**REGULAR MEETING  
CONSERVATION COMMISSION  
1 JUNKINS AVENUE  
PORTSMOUTH, NEW HAMPSHIRE  
SCHOOL DEPARTMENT CONFERENCE ROOM**

**September 11, 2024**

TO: Conservation Commission Members  
FROM: Kate Homet, Associate Environmental Planner; Peter Britz,  
Director of Planning and Sustainability  
DATE: September 6, 2024  
SUBJ: September 11, 2024 Conservation Commission Meeting

**Response to Conservation Commission Comments**

**C-301**

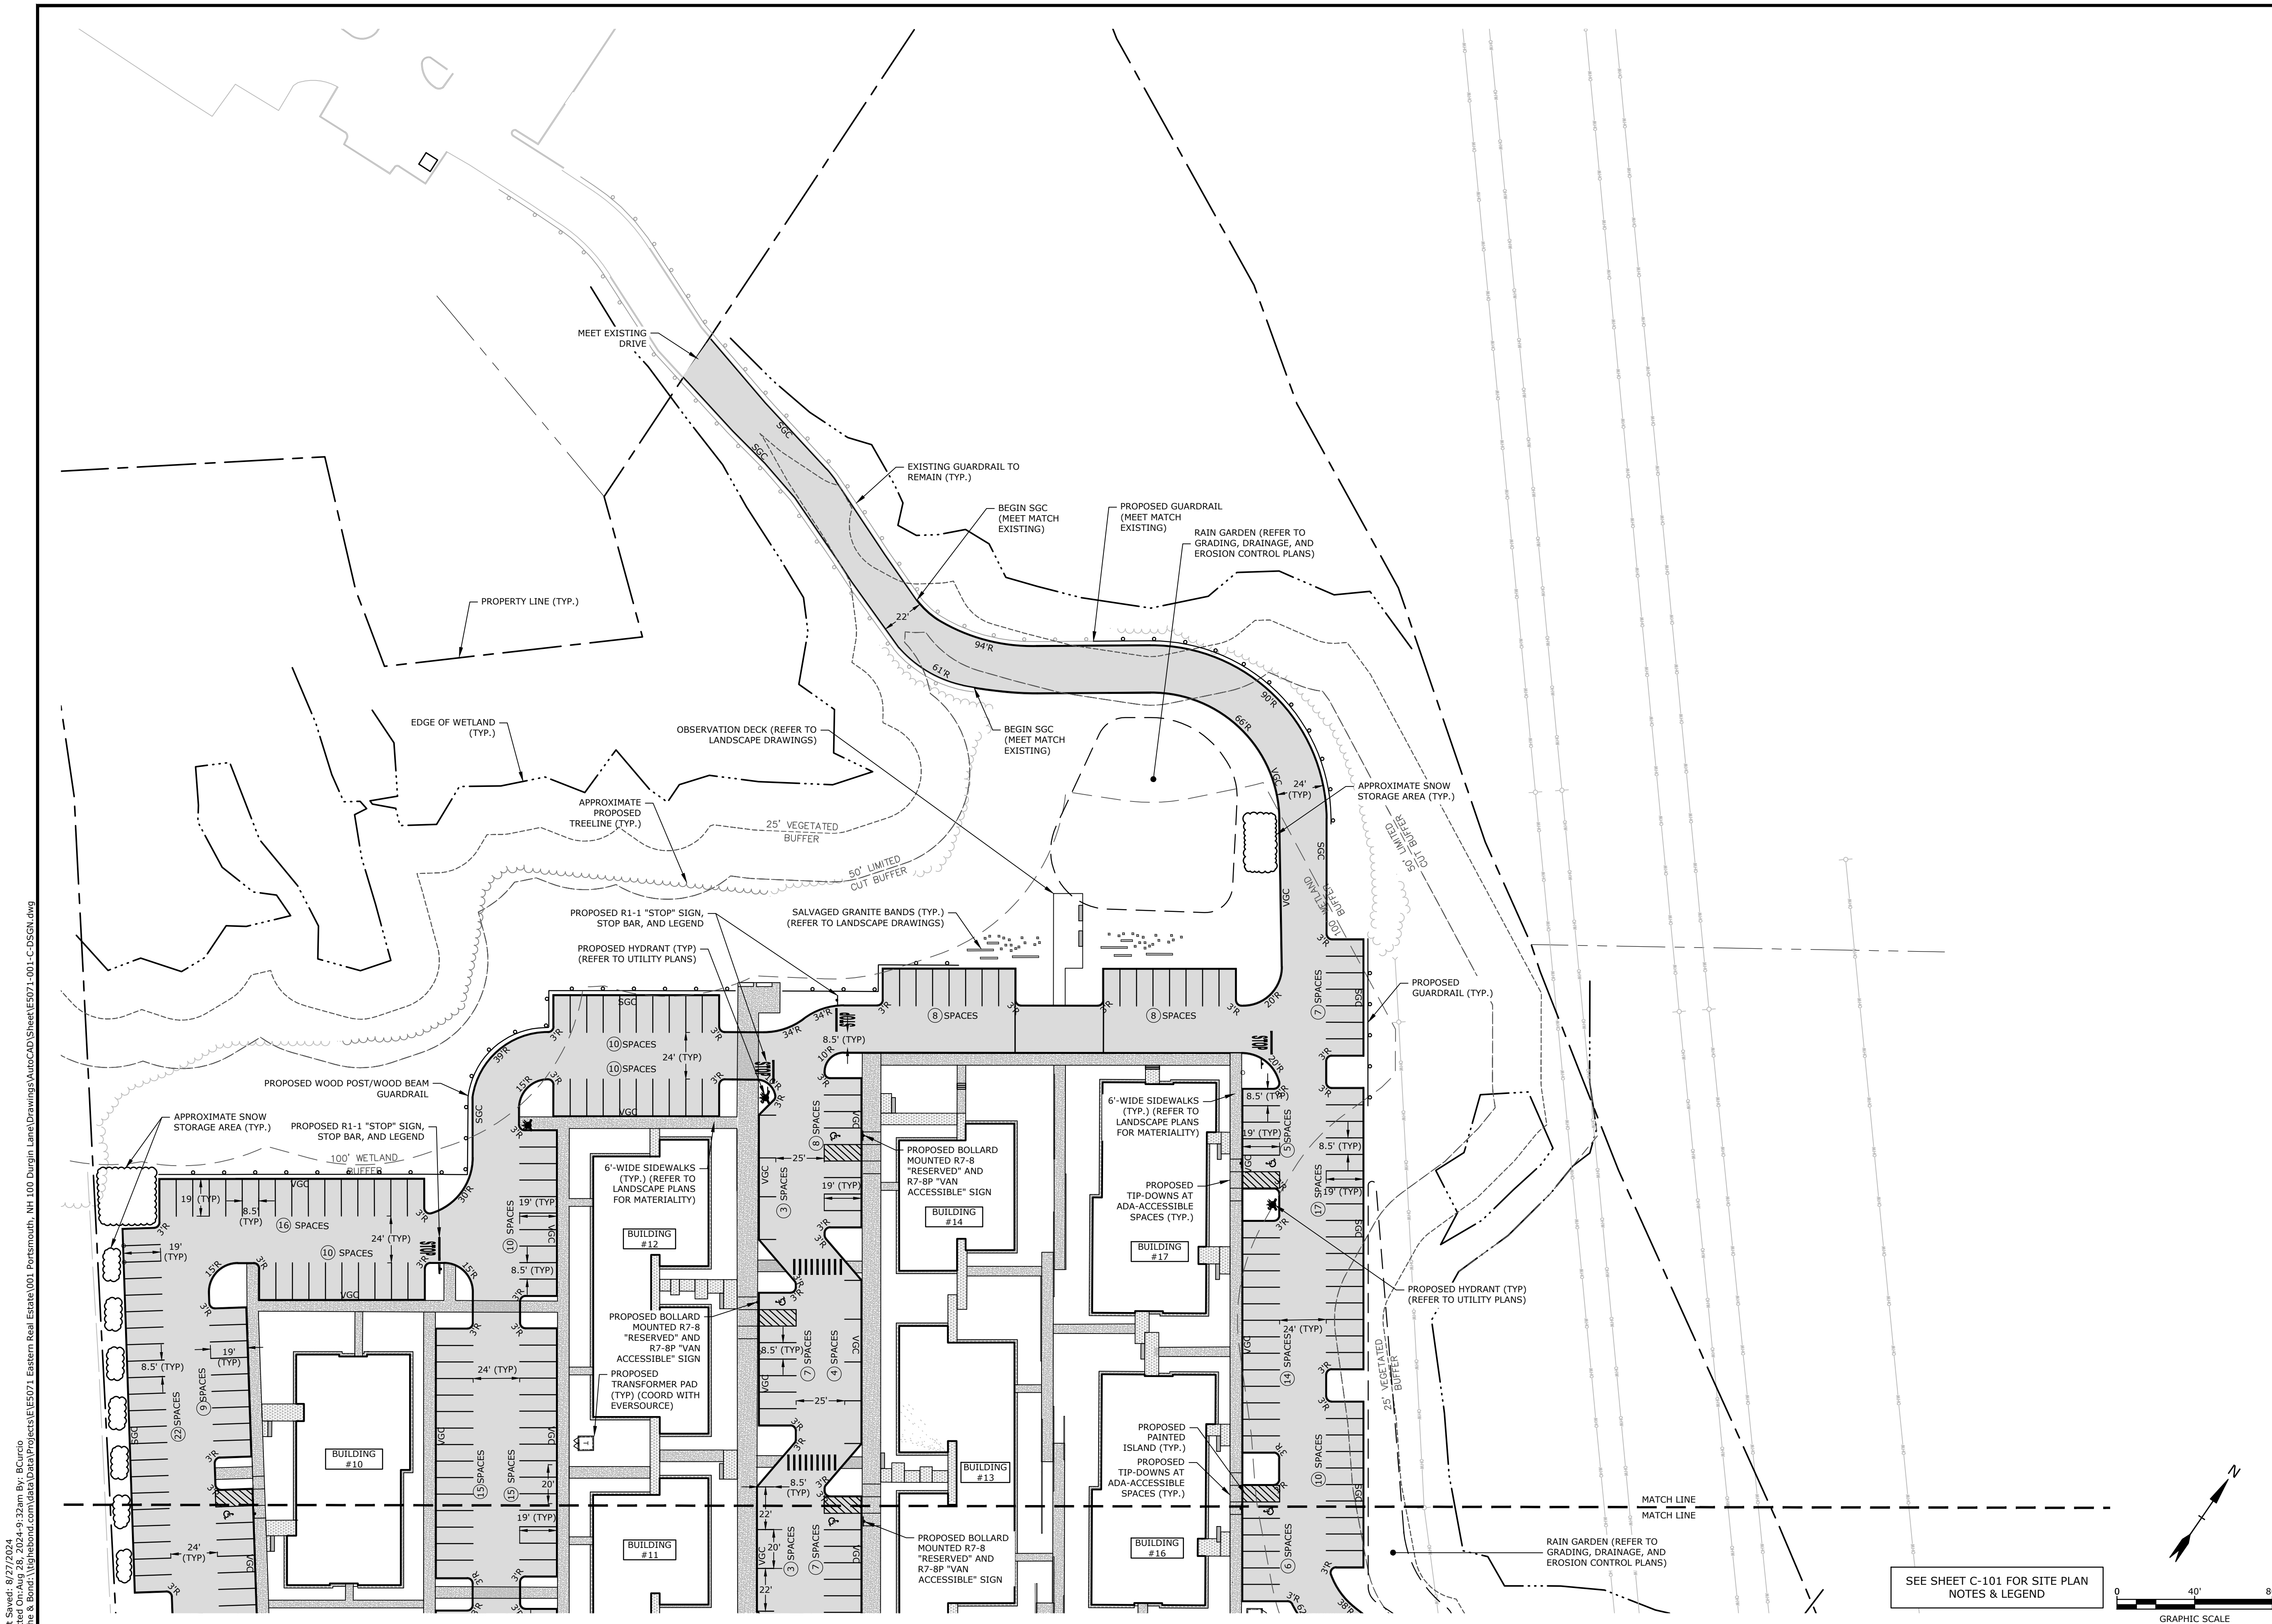
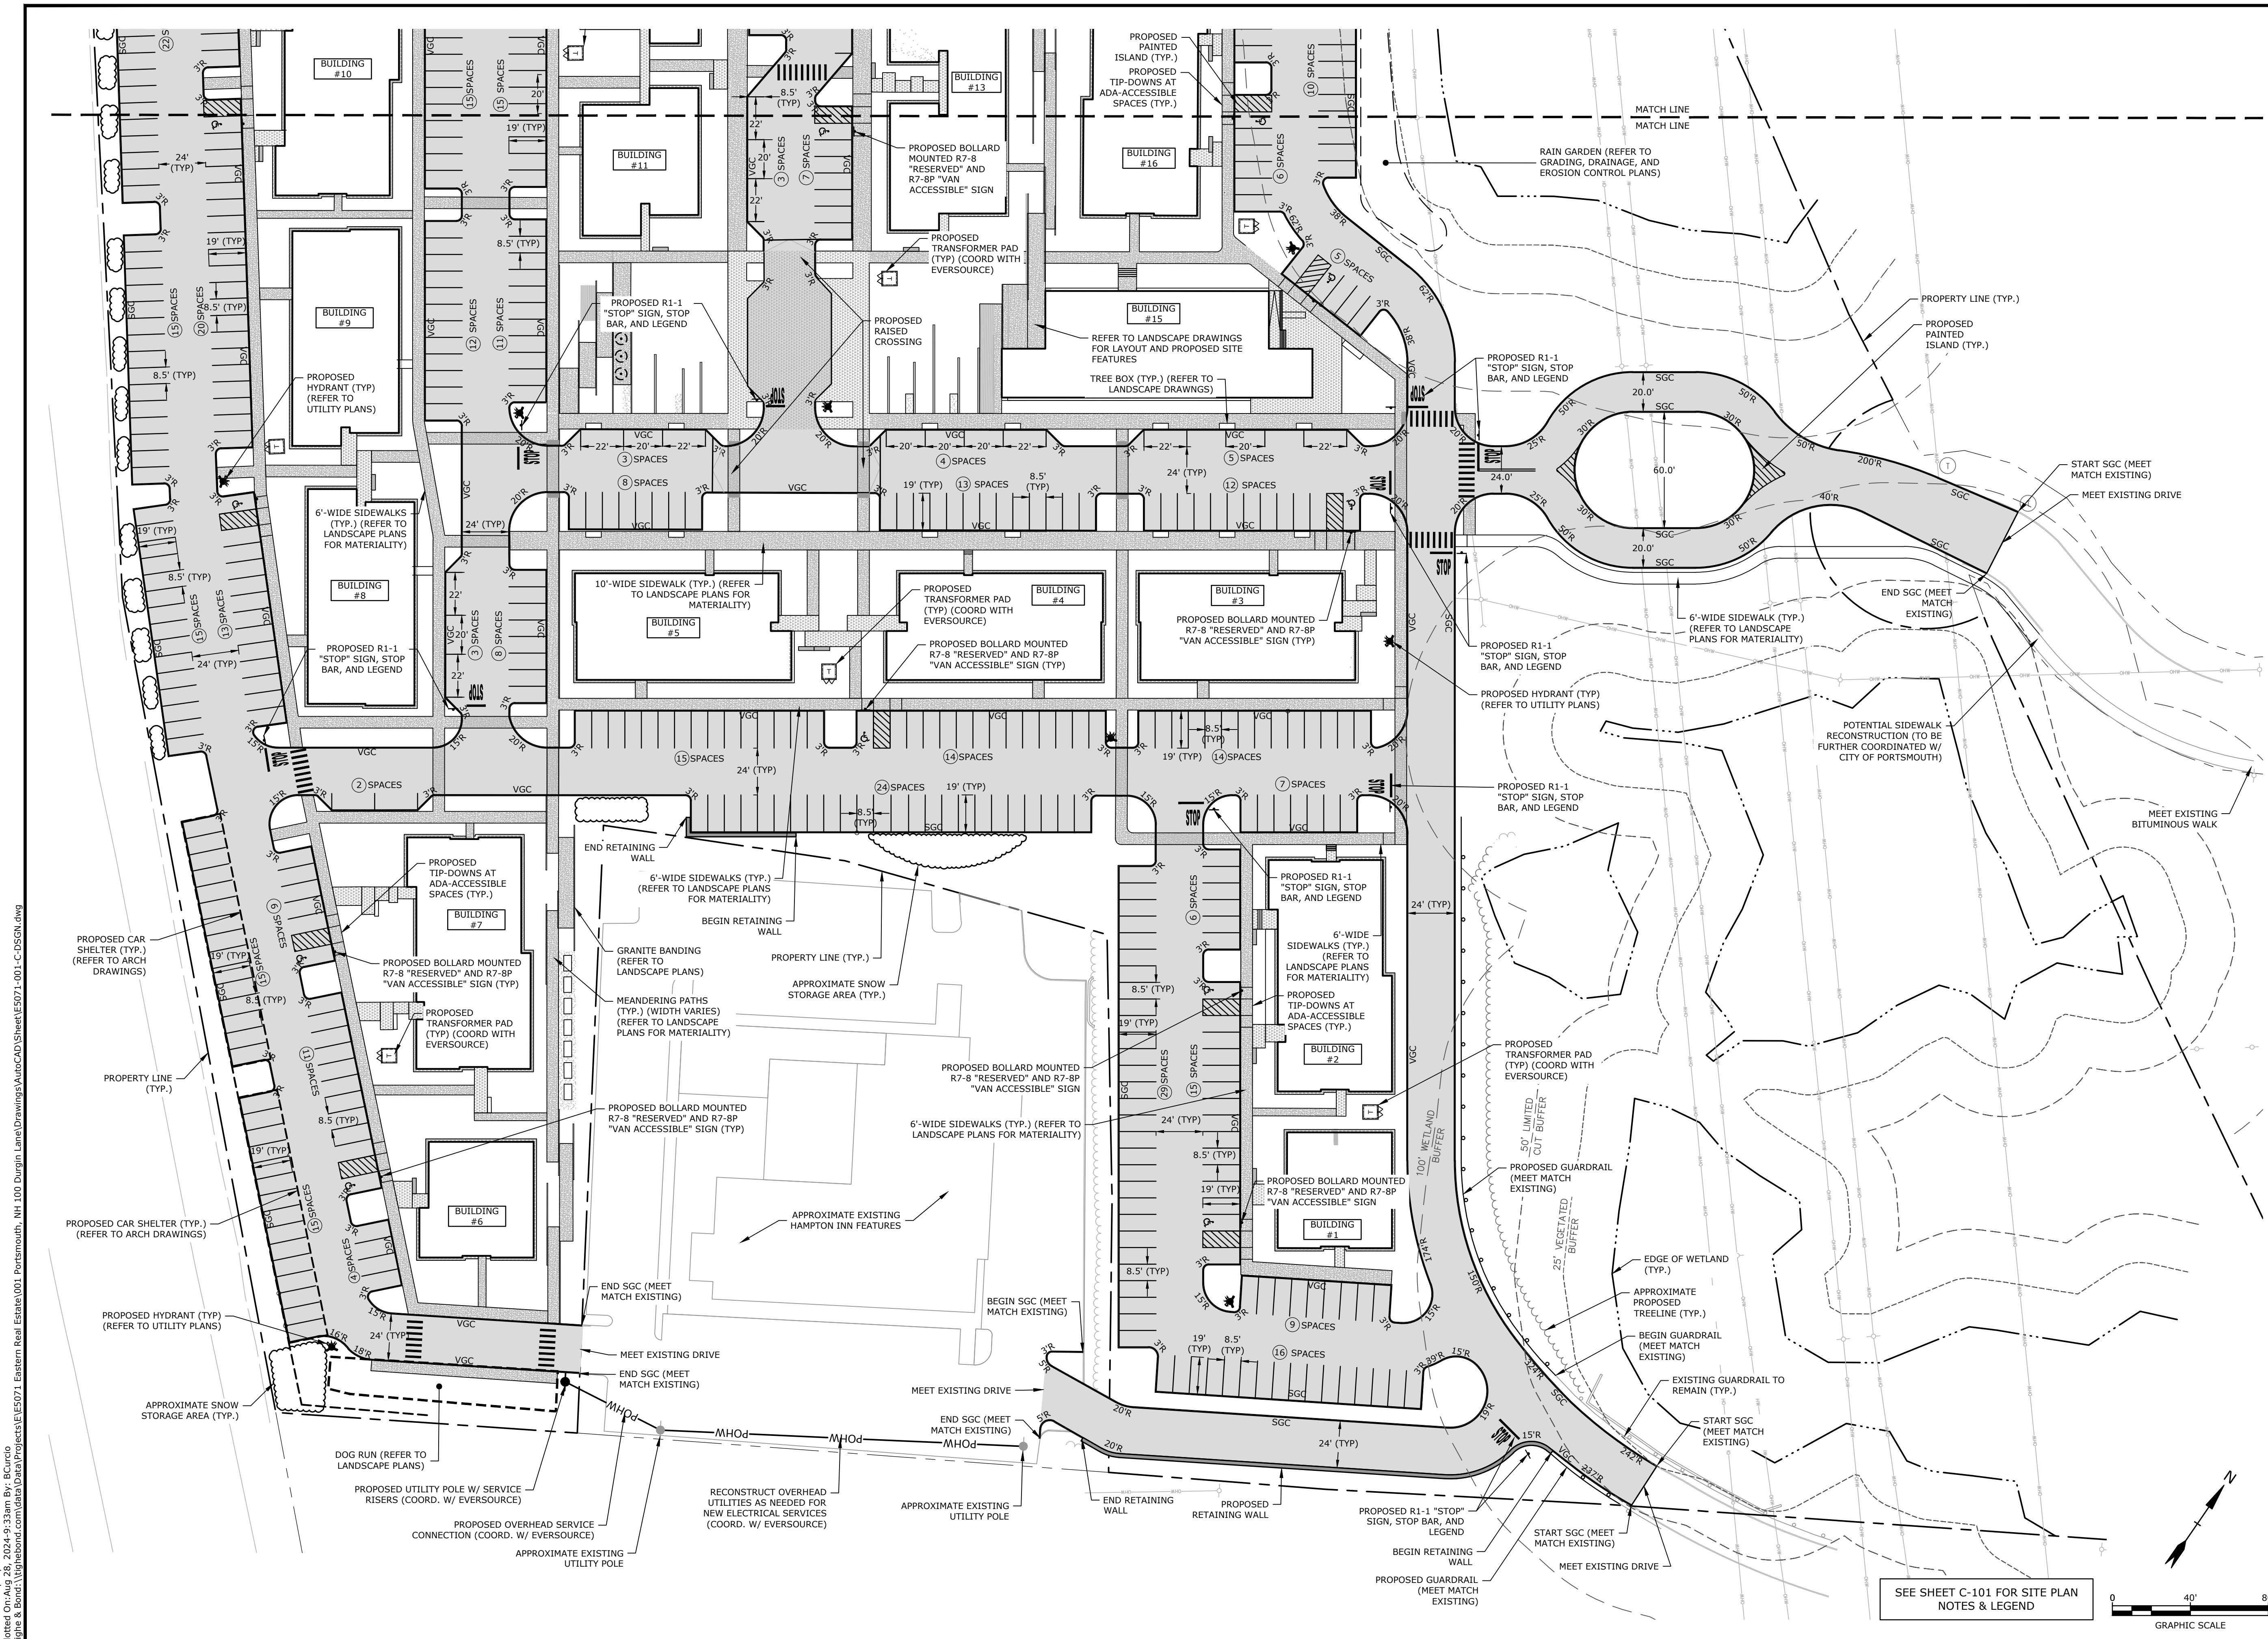
4. *Snow removal plan. Ensure that storage is limited to areas outside of buffer and vegetated areas.*

**Response:** Snow storage areas are shown on the Site Plans (C-301 and C-302). Snow will be hauled off-site and legally disposed of when snow storage areas have reached capacity, as described under Site Note #15 on C-101. .
